MS9447
AMENDMENT 1
8 July 2003

MILITARY STANDARD

BOLT, MACHINE-STEEL AMS 6304, DIFFUSED NICKEL-CADMIUM, PLATED, HEXAGON HEAD, DRILLED, .625-18 UNJF-3A

This amendment forms a part of MS9447, dated 21 December 1962, and is approved for use by all Departments and Agencies of the Department of Defense.

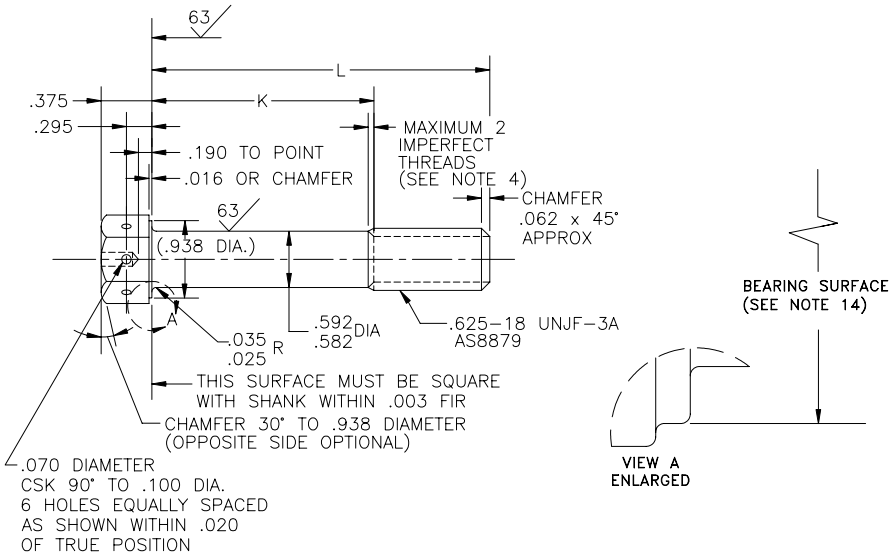
In drawing: Replace front view with this drawing and add view A:
